HOPE CREEK GENERATING STATION  
DOCKET NO. 50-354  
FSAR COMMITMENT STATUS THROUGH JULY 1984

ATTACHMENT I  
HOPE CREEK GENERATING STATION  
FSAR COMMITMENT STATUS THROUGH JUNE 1984

FIGURE 9.1-3

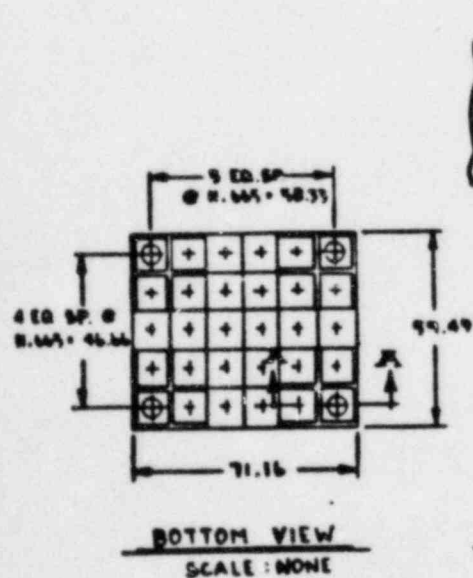
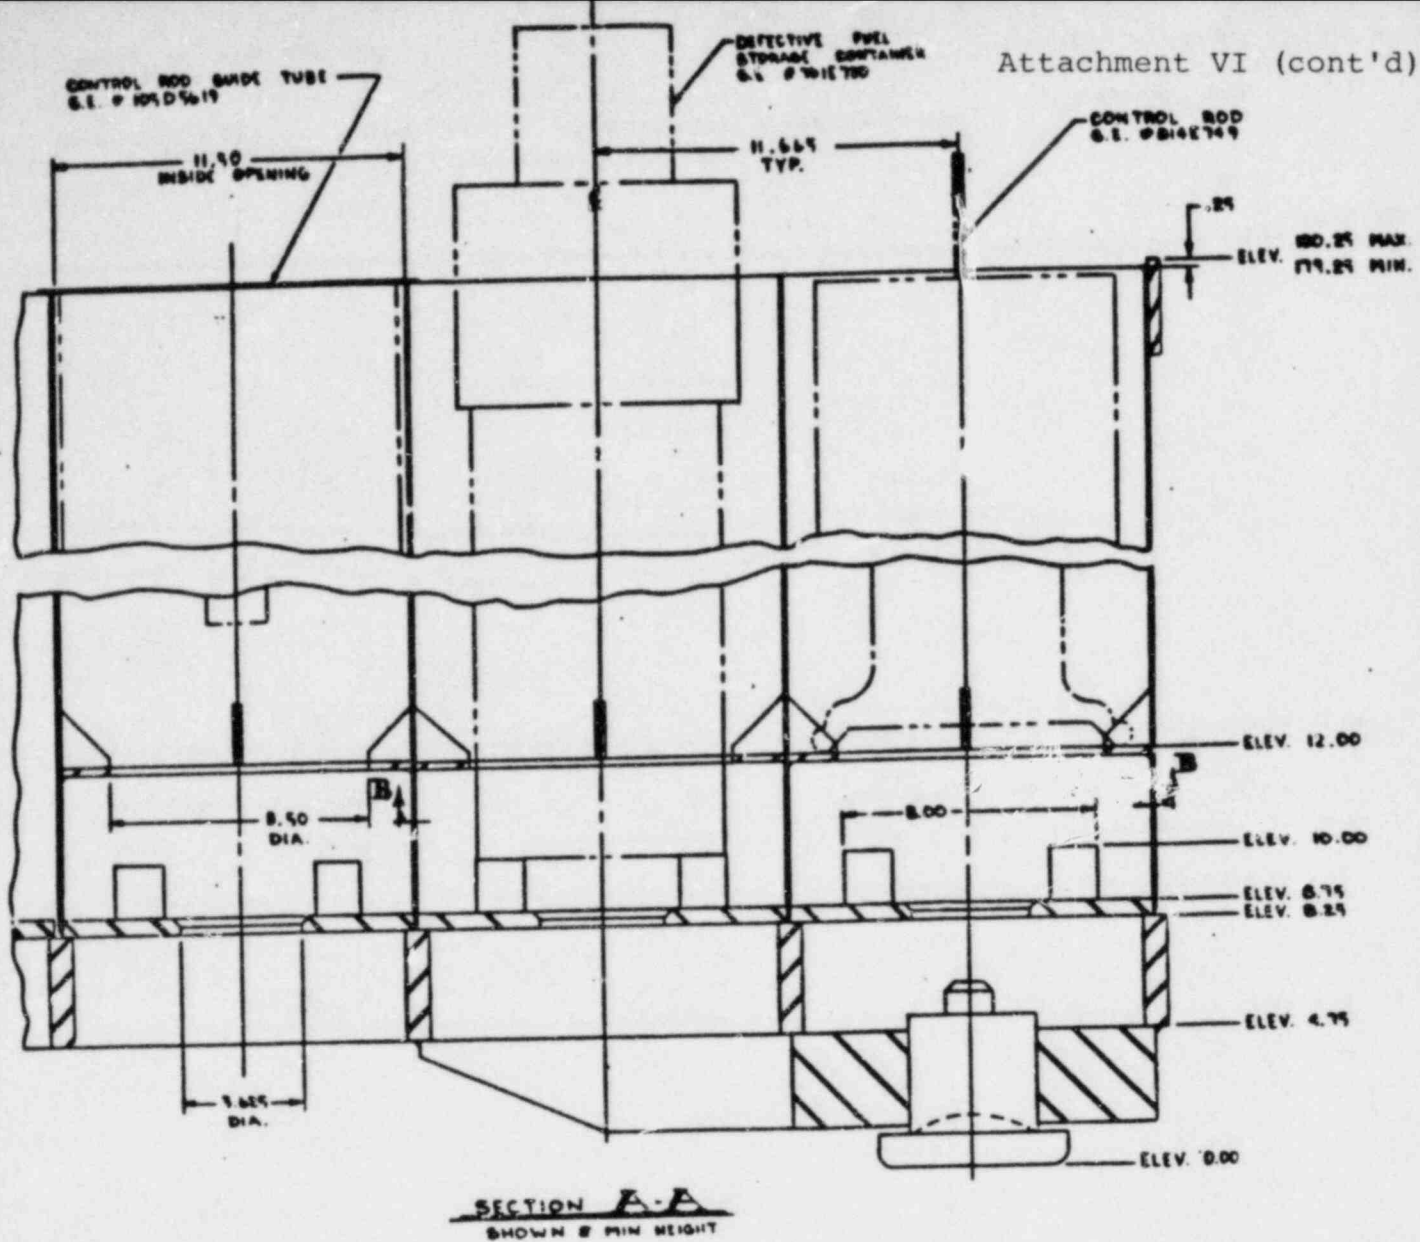
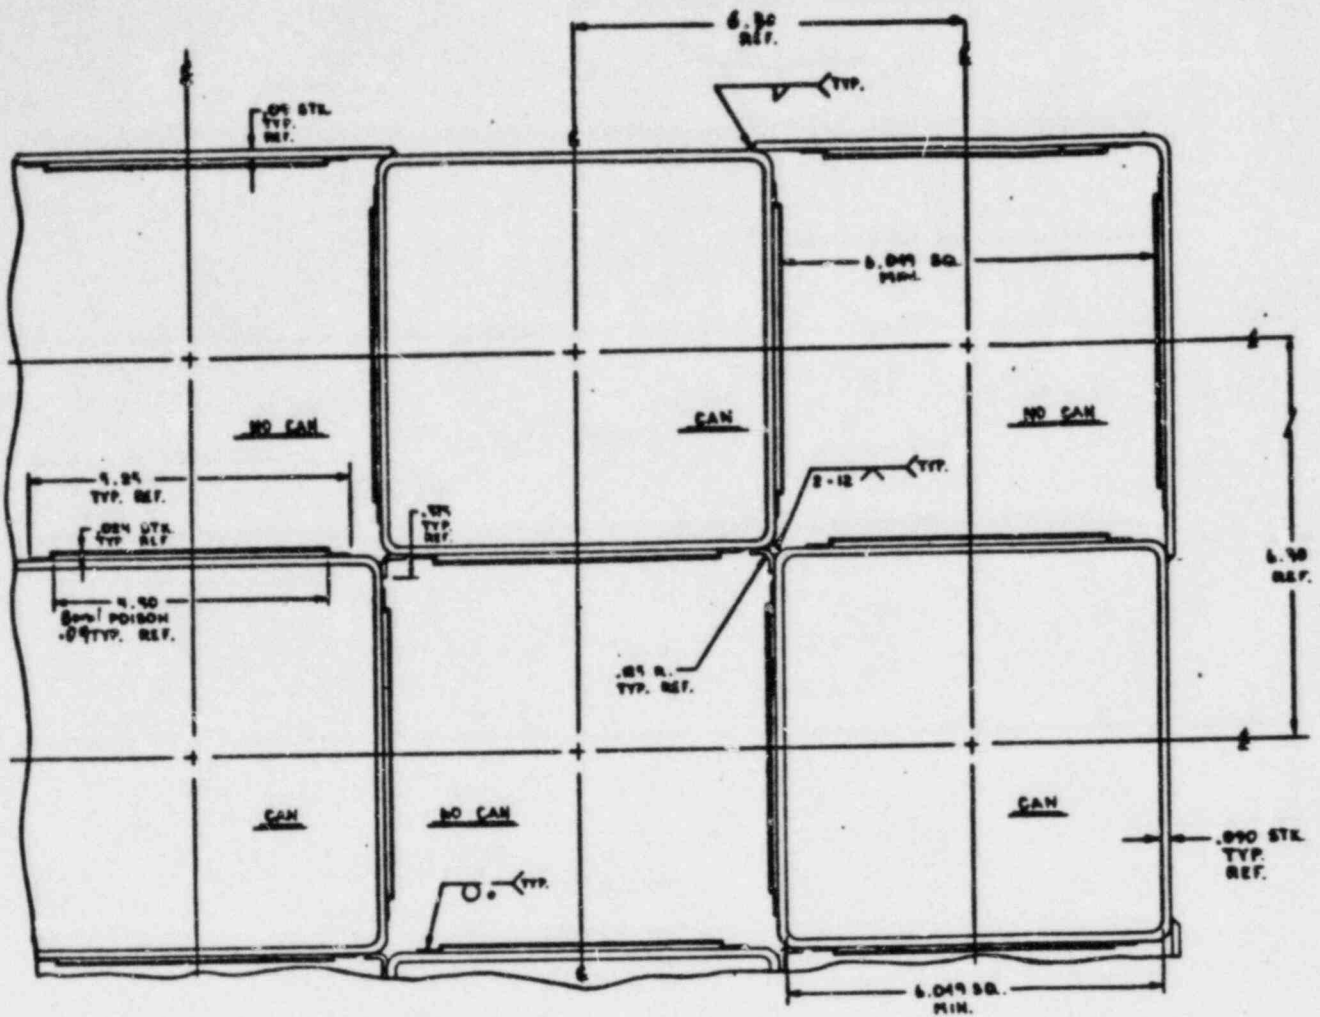
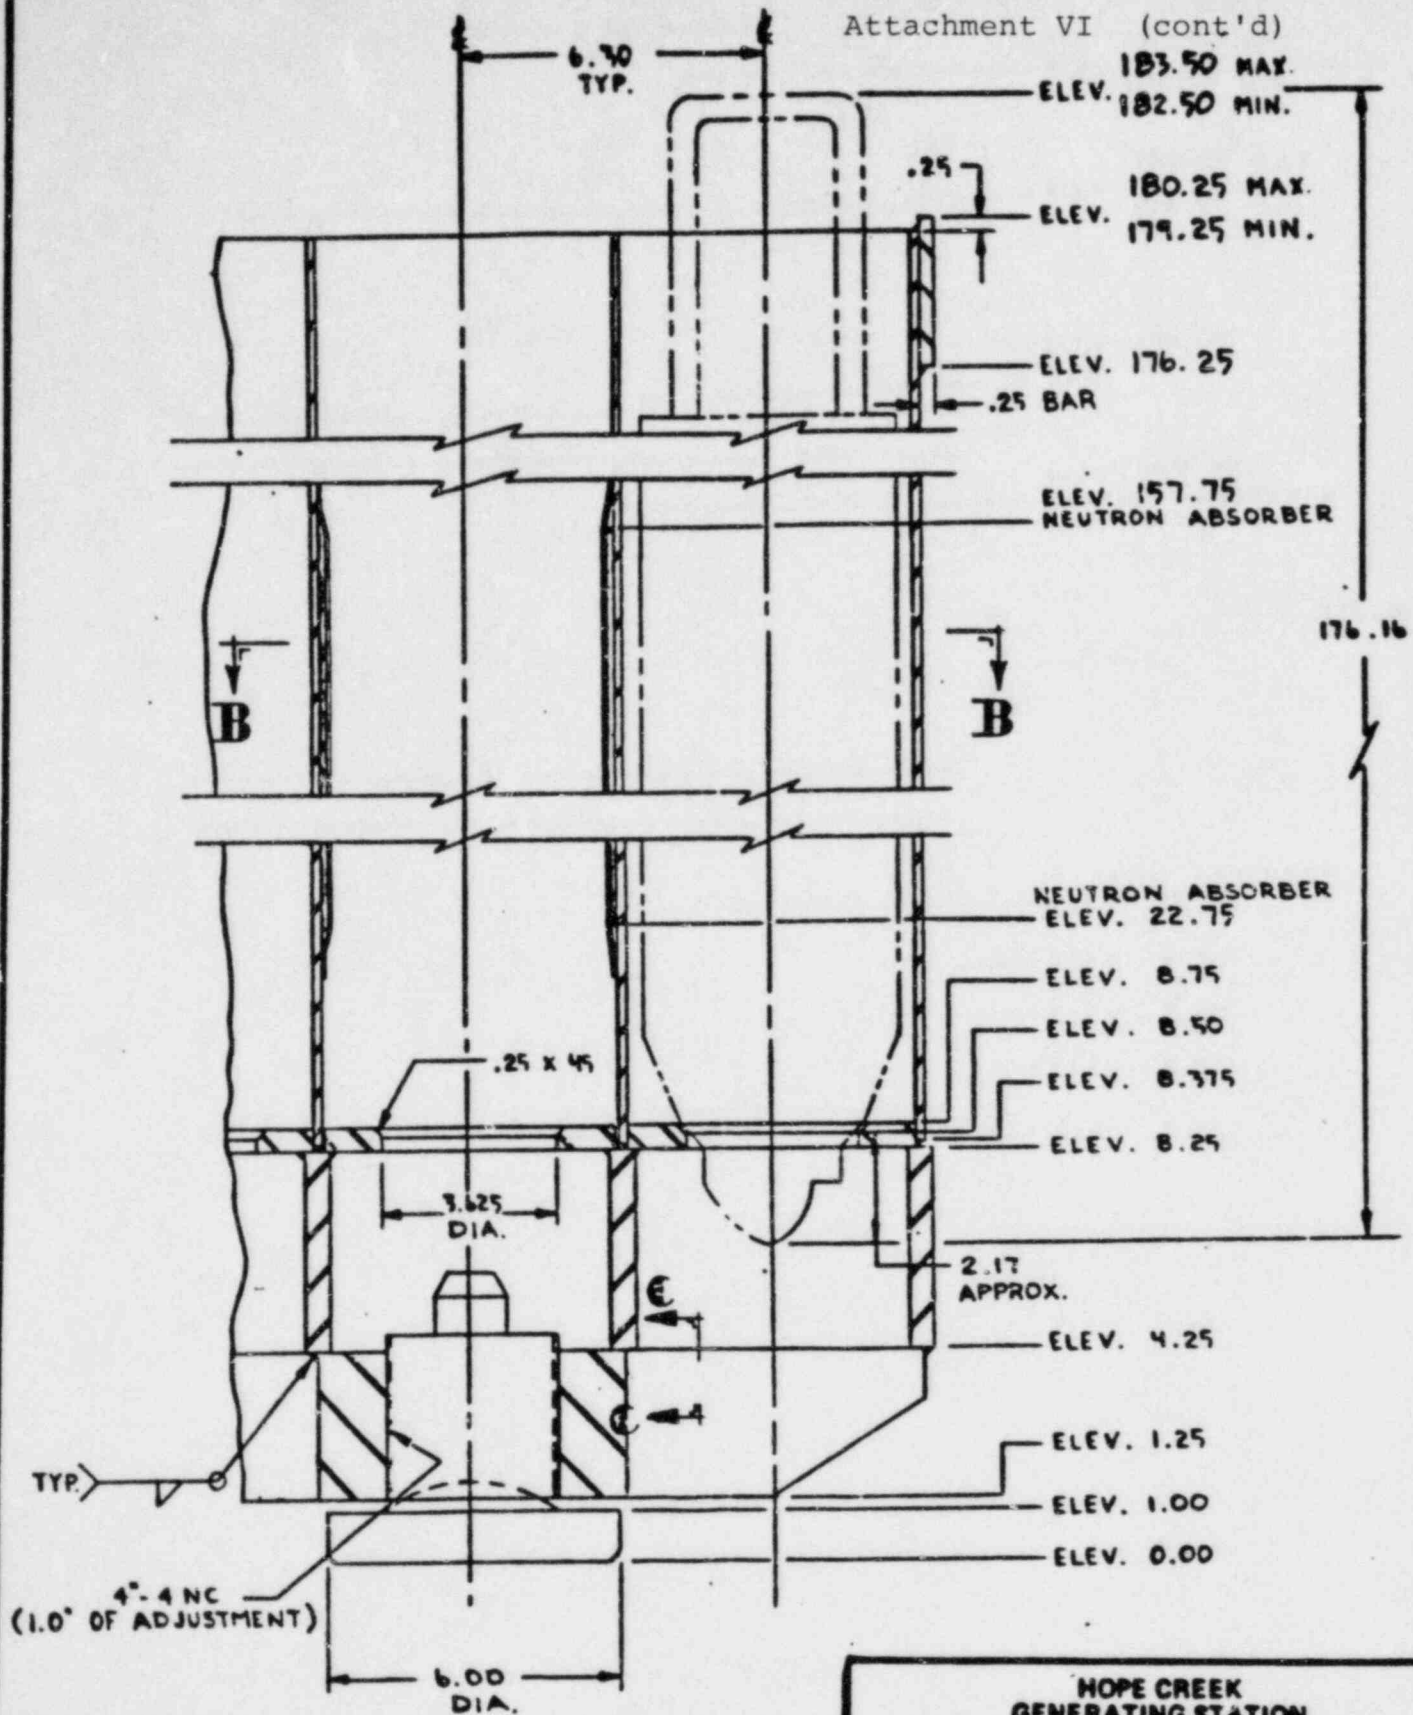
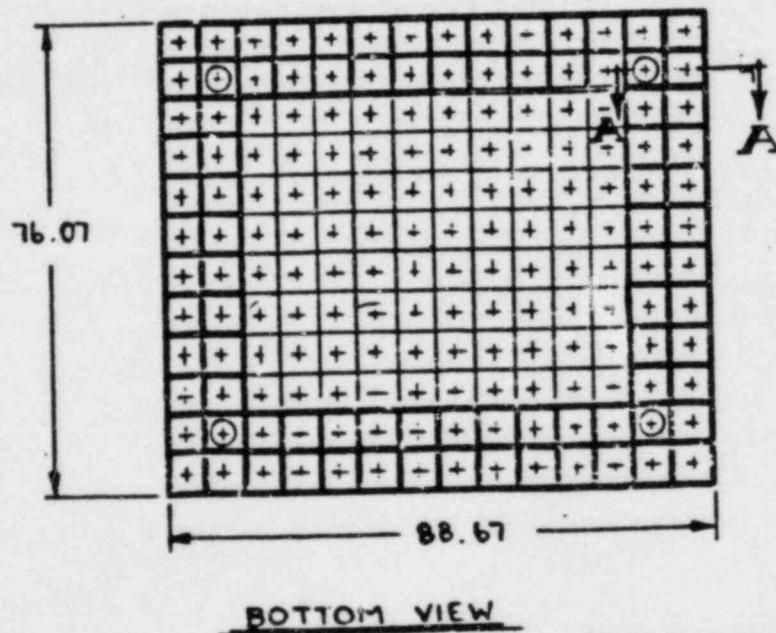
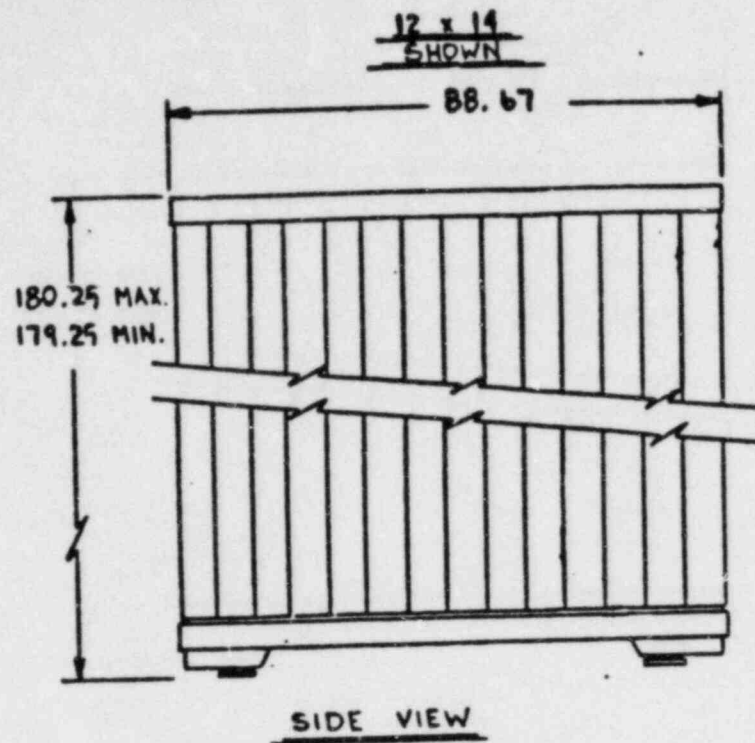
Without the spent fuel storage rack design details, the results of an analysis of impact onto the racks and the bundle-to-bundle fuel spacing, the staff cannot make any favorable conclusions about the design. Provide this information in the FSAR.

Section 9.1.2 and Figure 9.1-3 have been revised to include  
^ The spent fuel rack design details. ~~will be available by June~~  
~~1984, and will be added to Section 9.1.2.~~

The spent fuel storage racks are of freestanding design and are not attached to either the fuel pool wall or the fuel pool liner plate. The racks are constructed of stainless steel, and the ~~details of rack construction will be provided prior to fuel load.~~ neutron absorber is Boral. See Figure 9.1-3 for ~~construction details~~ design of a typical rack and the special rack.
